UNITED STATES PATENT AND TRADEMARK OFFICE

Office Action Summary

10/670,227

BARANGER ET AL.

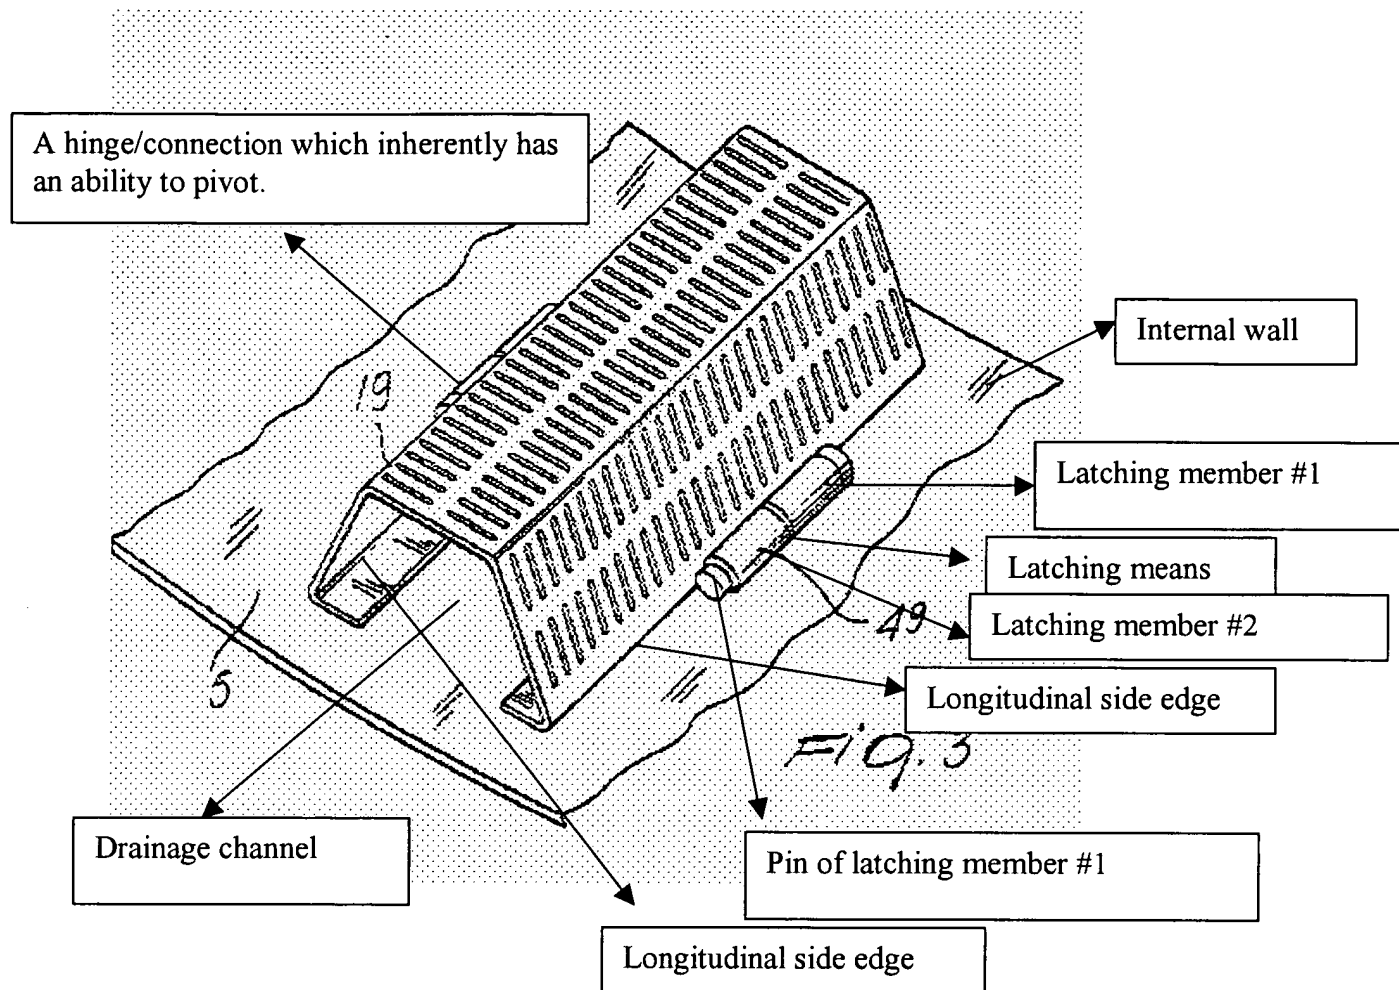
Regarding claim 1, Diotalevi discloses a draining unit for a press comprising at least one elongated, profiled element (19) which contain a plurality of spread-out holes (fig. 3), said element extending along the internal wall (5, fig. 3) of the press and forming a drainage channel together with the wall through contact at two longitudinal side edges (fig. 3), wherein the profiled element (19) is interlocked with said wall at one of its side edges by means of a connection (49) with an ability to pivot. Diotalevi discloses that the profiled element (19) is easily opened (col. 2, lines 51-55) from the vat by utilizing a latching means/hinges (49), therefore, the latching means adapted to lock said profiled element (by sliding the latching means into a pin (see below)) in a position with its two side edges resting against said internal wall so as to form the drainage channel (see the illustration below).

Regarding claim 4, Diotavely discloses the longitudinal side edges of the profiled element (19) are extended by inwardly folded shoulders forming two parallel bearing strips (see fig. 3) for said profiled element (19) in the position in which it is turned down to form the drainage channel, the profiled element (1) being shaped so that, in the turned-down position, it defines a drainage channel (4) of rectangular section by cooperation with the wall (3) of the vat (2) (fig. 3).

Regarding claim 13, Diotavely discloses the latching means is formed by two members (see illustration above), one (latching member #1) of which is interlocked with the profiled element (119) and the other of which is interlocked with wall (latching member #2) of the vat, the two members being capable of being inter-engaged to lock the profiled element (1) in position and disengaged through translation of said profiled element (1) in opposite directions.
